Appendix A1

Rossett Flood Map Enquiry

Appendix A2 National Resources Wales

LAND NORTH & SOUTH OF ROSSETT ROAD—SITE RO004AS :- SOUTHERN PARCLE OF LAND

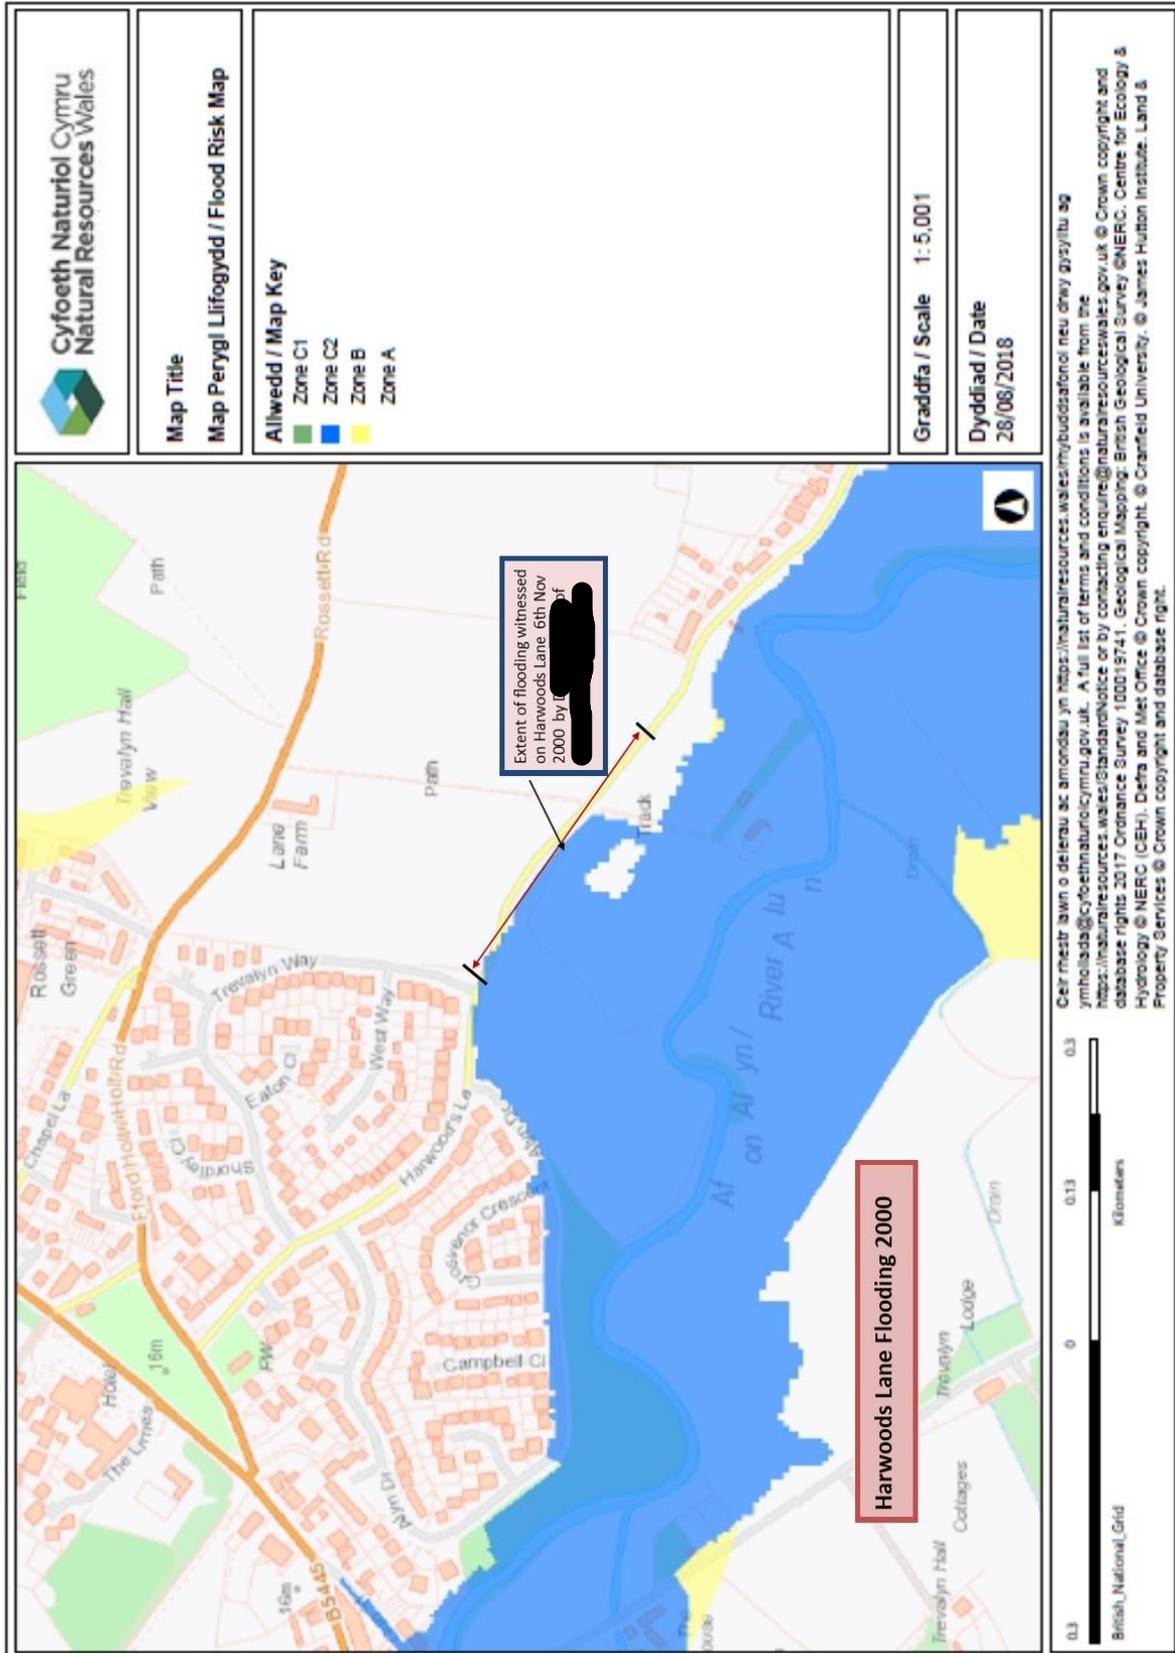
The River Alyn reached a very high level on Harwoods Lane and sandbags were deployed at the highest point of the lane just short of the first Cottages in Harwoods Lane at Trevalyn Hall View. I have marked the high point on the attached map and confirm that the water rose to a height that made Harwoods Lane impassable for a considerable period of time.

Harwoods Lane—Flooding High watermark and sandbag line Nov 2000

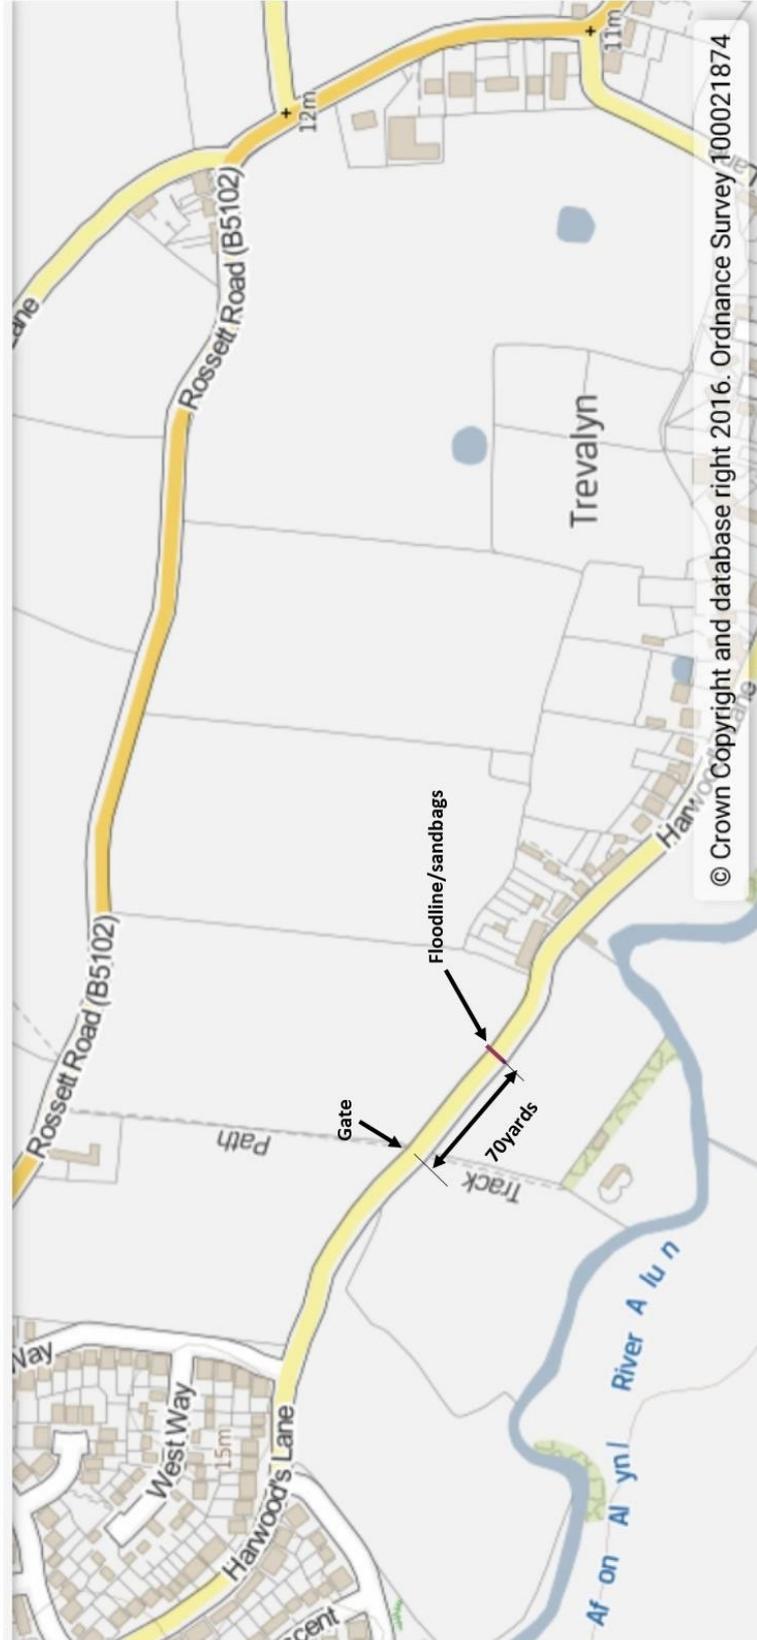
I, Mr [REDACTED], Rossett [REDACTED] witnessed at first hand the River Alyn flooding in the last few years. I have lived in Rossett all my life and have seen flooding to the River Alyn on a number of occasions the worst two events were about 20 years ago and before that sometime in the 1970s. I cannot remember the exact dates but both events resulted in the closure of Harwoods Lane for a period of about 1 week. On the most recent event I recall that the flood water rose gradually during the day and reached the high point in the evening on Harwoods Lane quite close to the [REDACTED] Cottages where I live. The road was sandbagged at the highest point on the road and the water reached about 1" just below the sandbag line. There was serious concern at the time that the flood water would overtop the road at its highest point and flood the cottages that were somewhat lower on the road that slopes gradually down towards Broad Lane. I confirm that I have indicated to [REDACTED] & [REDACTED] [REDACTED] the highest point to which the flood water reached on the lane closest to [REDACTED] Cottages. The high water mark I indicated is shown on the attached plan.

Note : The road was sandbagged at the highest point on the road and the water reached about 1' just below the sandbag line during the 2000 flooding.

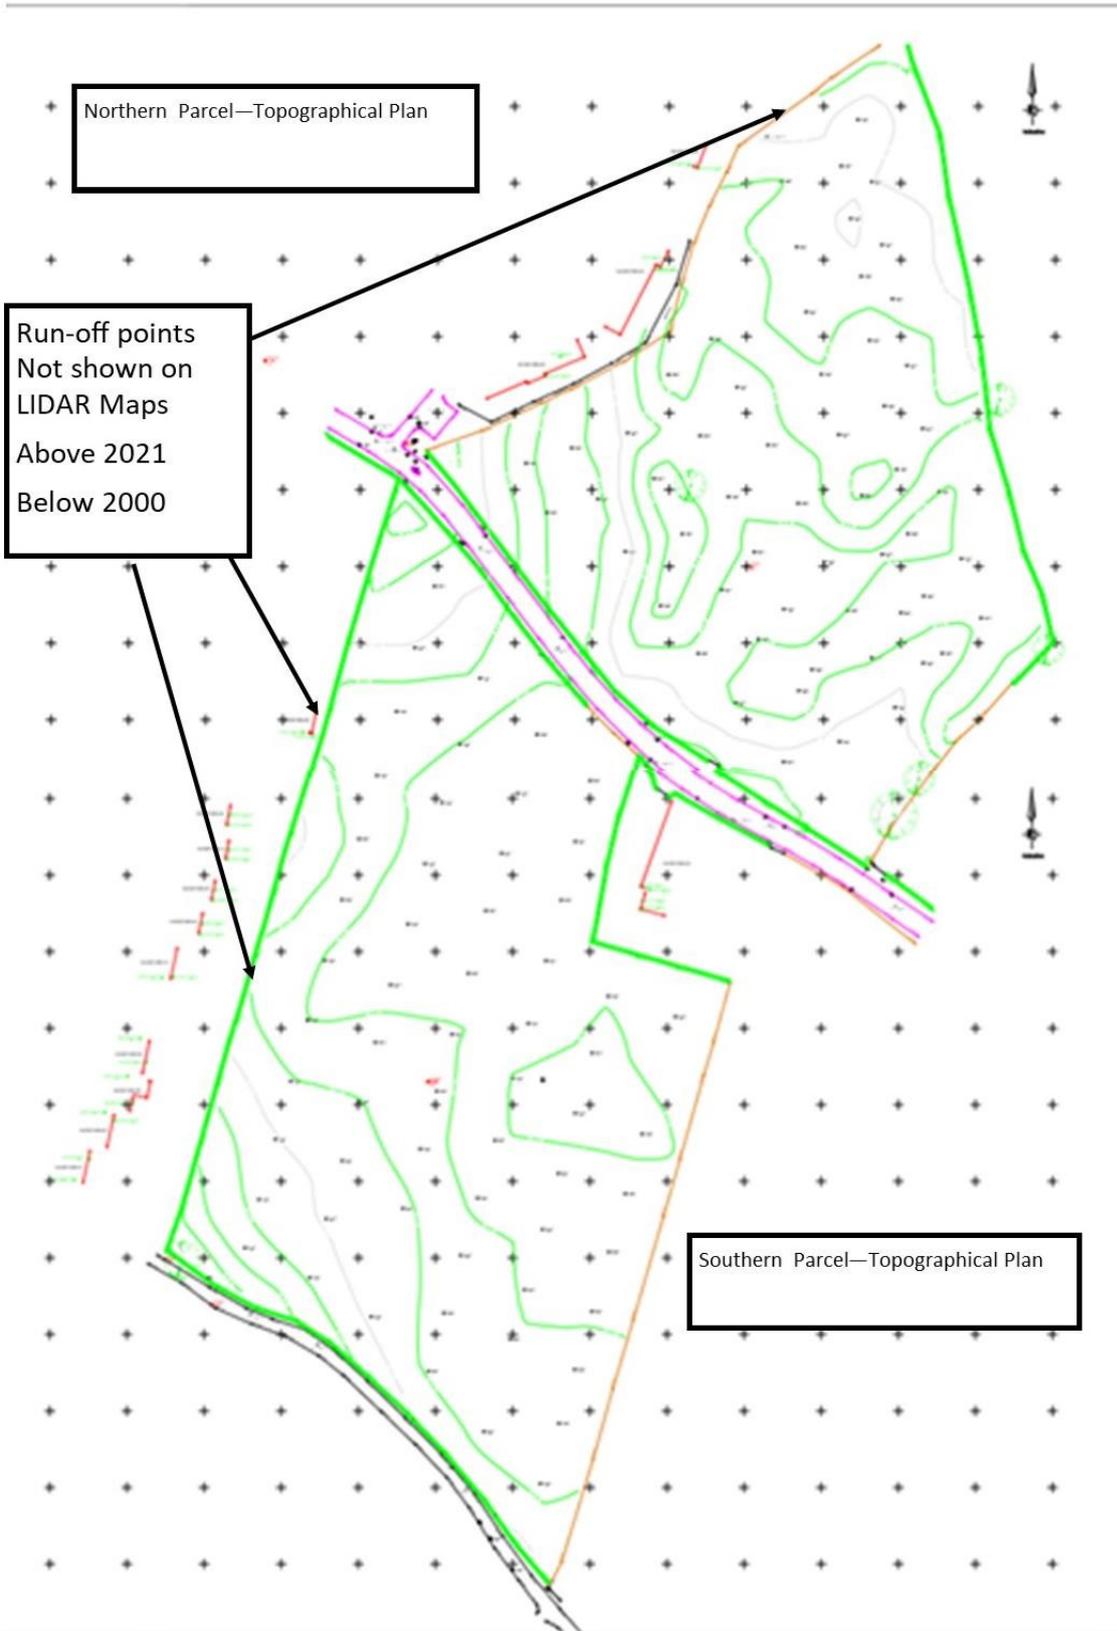
SURVEY MEASUREMENTS TAKEN 07 Feb 2019 by [redacted], [redacted] and [redacted].
 Level change taken between the entrance gate and the sandbag line identified by [redacted] & [redacted].
 Both of Trevalyn at the time of the most recent River Alyn Flood on 6th November 2000. Sandbag line location confirmed by [redacted] WCBC Duty Flood officer for 6th November 2000. Difference in levels:-
 Gate threshold to Southern parcel of land 140mm lower than sandbag line on Harwoods Lane.
 (Gate Threshold + 470mm above manhole 12.76 OD datum, sandbag line 610mm above manhole datum.)

NRW - Reorded Flood Outlines -2000

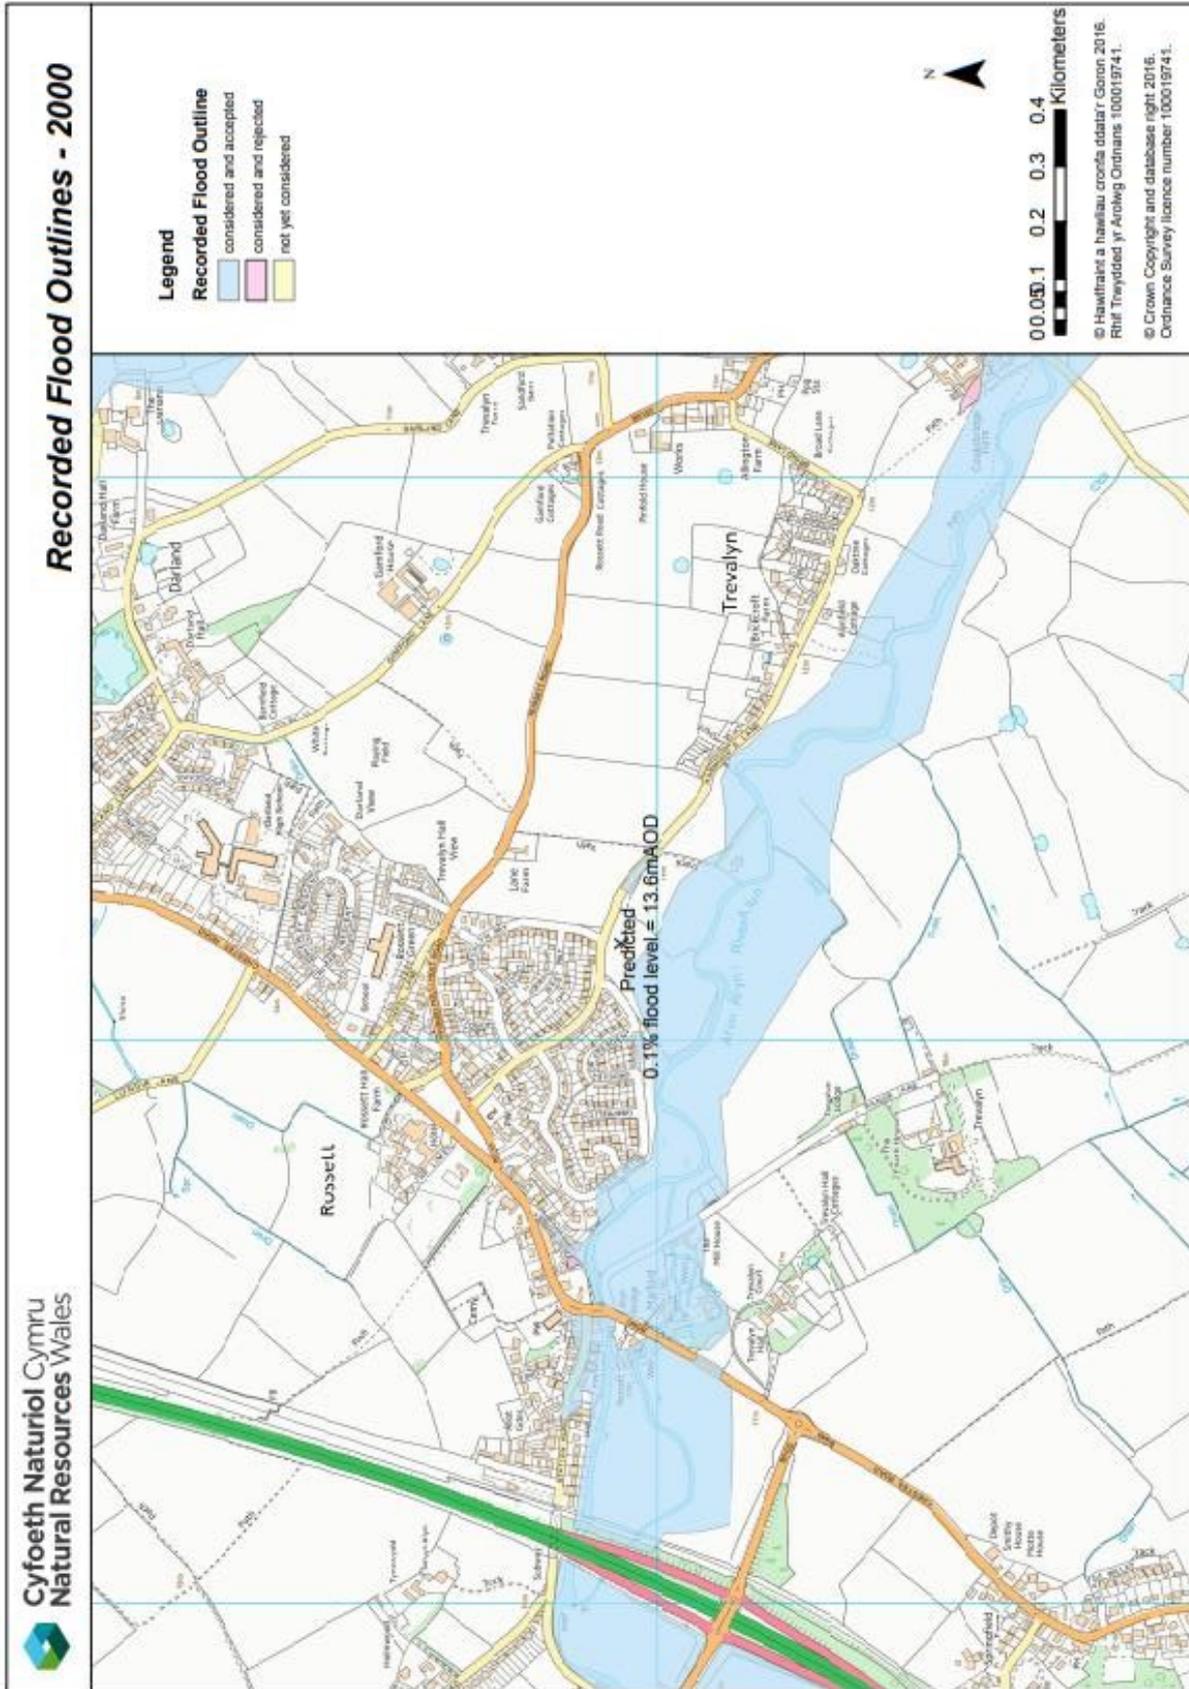
Note This NRW Flood Outline map does not accord with the agreed NRW Flood Outline Nov 2018 on Page 9.
